REQUEST

Current Zoning: R-12MF(CD) (Multi-Family Residential, Conditional)
Proposed Zoning: N2-A(CD) (Neighborhood 2-A, Conditional)

Approximately 3.16 acres located west of Marsh Road, south of Auburn Avenue, and east of Hartford Avenue.

SUMMARY OF PETITION

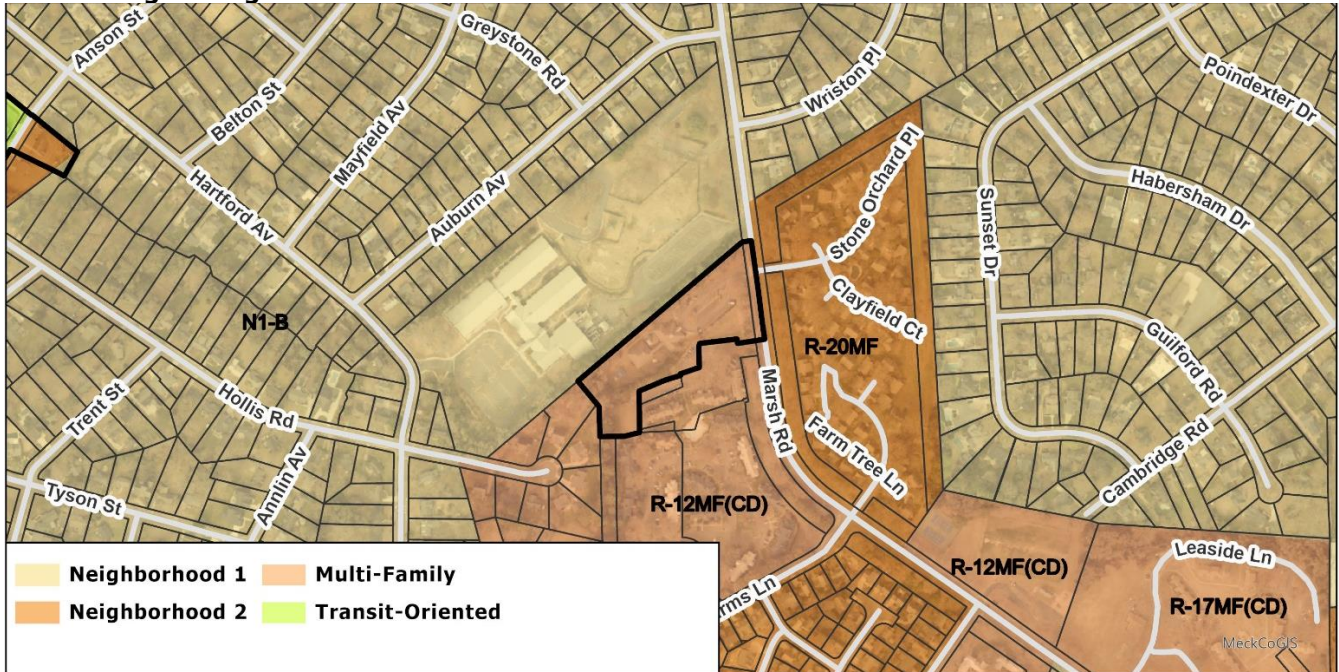
5. ~~Entitlement Services: There is an approximately 60' berm along the front of the property. Adjust the site design to be consistent with existing development along Marsh Road which incorporates large setbacks.~~ **ADDRESSED**

6. ~~Entitlement Services: Please specify what type of open space is being proposed.~~ **ADDRESSED**
7. ~~Urban Design: Expand the footprint of open space and increase minimum open space dimension The allocation of 10' in front of the units for open space is narrow and will not be ample to program or activate with quality open space.~~ **ADDRESSED**

- A 60' setback will be provided along Marsh Road, with enhanced plantings to maintain the existing berm and Marsh Rd. character.
 - One large maturing tree will be planted every 50 feet, and one small maturing tree every 25 feet, using deciduous or evergreen species.

- Buildings will be separated by a minimum of 10 feet, as shown on the Rezoning Plan.
 - Publicly accessible open space will be centrally located and designed for multiple users with dynamic, programmable features.
